Project	IEEE 802.16 Broadband Wireless Access Working Group <http://ieee802.org/16>		
Title	Handover of Mobile Relay Station		
Date Submitted	2007-01-08		
Source(s)	Kaibin Zhang, Gang Shen, Jimin Liu, Shan Jin Alcatel-Lucent, Research & Innovation 388#, Ningqiao Road, Shanghai, P. R. China	Voice: 86-21-50551240-8194 Fax: 86-21-50554554 Email: gang.a.shen@alcatel-sbell.com.cn	
Re:	A response to a Call for Technical Proposals regarding IEEE 802.16j.		
Abstract	The document describes provides a handover method for the Mobile RS.		
Purpose	The document is submitted for review by 802.16 Working Group members.		
Notice	This document has been prepared to assist IEEE 802.16. It is offered as a basis for discussion and is not binding on the contributing individual(s) or organization(s). The material in this document is subject to change in form and content after further study. The contributor(s) reserve(s) the right to add, amend or withdraw material contained herein.

Handover of Mobile Relay Station

Figure 1 MRS handover process

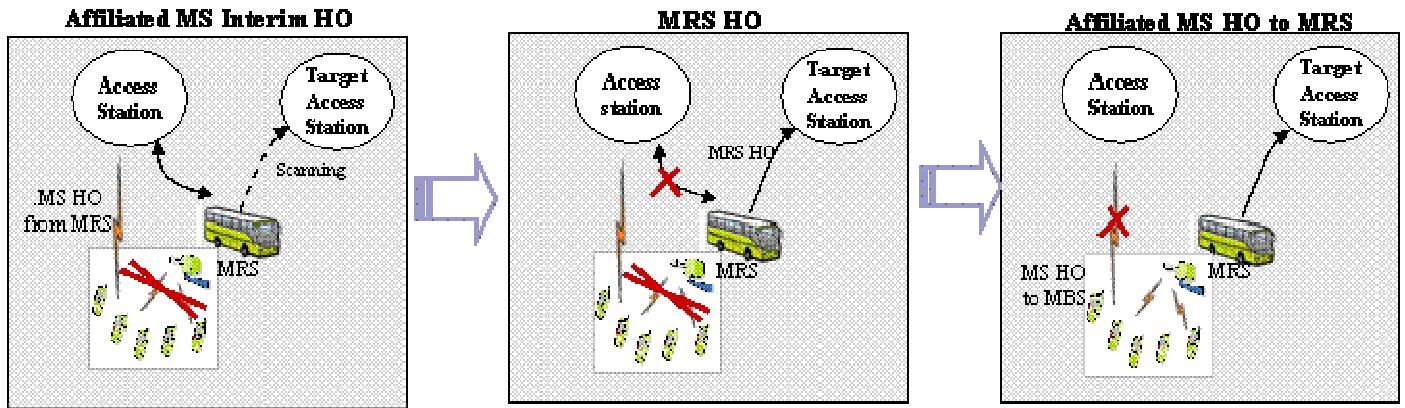
In the in-band relay scheme, when Mobile RS is moving across two neighboring access stations, both MRS and its affiliated MS shall experience a handover process. As illustrated in Figure 1, In order to maintain the service continuity of MS, it is proposed to divide the handover process into several steps:

- **MS intermediate HO.** Before MRS tries to scan potential target MR-BS or RS, the affiliated MS handover from its access MRS to the target access station, which could be the serving MR-BS or other neighboring RS with better signal quality. This handover could be triggered by decreasing the MRS power level or initiated by the serving MR-BS. If the MRS and the target access station have different preambles, the MS would follow the handover process as defined in section 6.3.22.2. If the preambles are same (e.g. intra-HO in transparent frame structure), the serving MR-BS shall conduct the handover process by updating the MAP and radio resource scheduling;

- **MRS HO.** Following the completion of MS intra-BS HO from MRS to the interim target access station (serving MR-BS or other RS), MRS shall performs cell selection by scanning neighboring target stations. If the HO decision is successfully initiated, MRS would follow the other procedures defined in 6.3.22.2 to complete the HO from the access station to target access station. If the HO trigger condition is not satisfied or it is failed to make the HO decision, the HO process will be canceled and the MRS shall re-connect with the access station. During MRS HO process, MS keeps communication with the interim target access station rather than the MRS;

- **MS HO to MRS.** After MRS completes the handover process, the quality of the radio link between the on board MS and the MRS would be better than others. Therefore, MS performs the handover from current serving station to MRS. If the MRS and the serving station have different preambles, the MS would follow the handover process as defined in section 6.3.22.2. If the preambles are same (e.g. intra-HO in transparent frame structure), the serving MR-BS shall conduct the handover process by updating the MAP and radio resource scheduling. The MS is not aware of this handover process.
